REGISTRY OF RADIOACTIVE SEALED SOURCES AND DEVICES
SAFETY EVALUATION OF SOURCE
(Amended in Entirety)

NO.: TX-1153-S-102-S

MODEL: BM06 Series (BM06-33, BM06-37, BM06-57, BM06-68, BM06-60, BA06-22)

MANUFACTURER/DISTRIBUTOR: International Isotopes Idaho, Inc.
4137 Commerce Circle
Idaho Falls, ID 83401

REVISIONS				
NO.	REV. NO.	DESCRIPTION	BY	DATE
		FIRST ISSUE

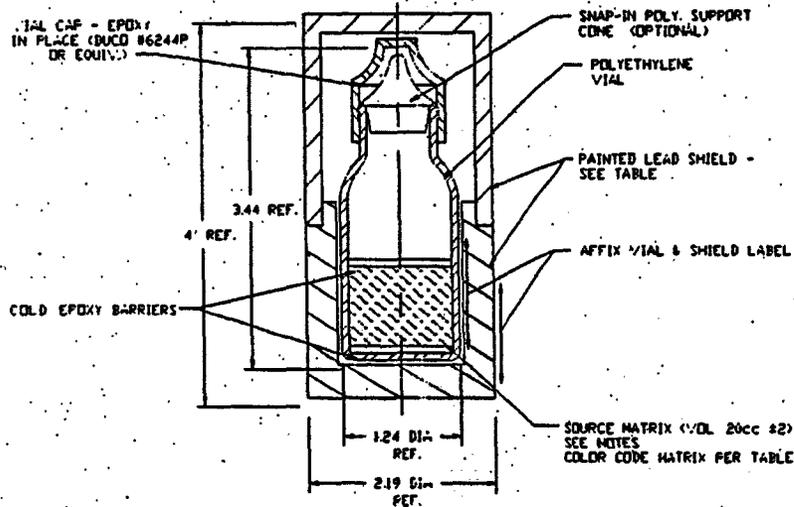
A revision to Drawing B004001 to include the new models, nuclides and color codes is attached with this letter for inclusion in the Sealed Source and Devices Safety Evaluation. An electronic copy in *.DOC format is enclosed.

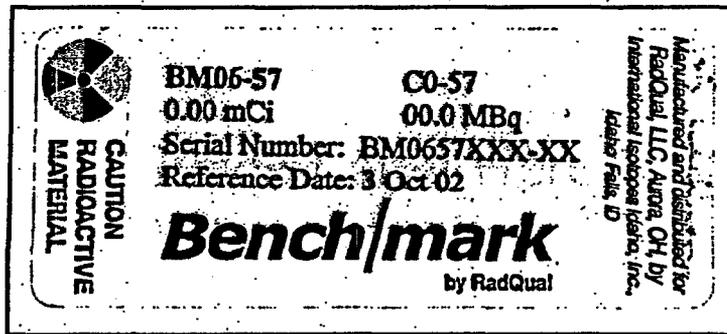
1. *Please provide a copy of the label to be placed on the source.*

2. *Please provide the dimensions of the label and identify the materials that go into construction of the label.*
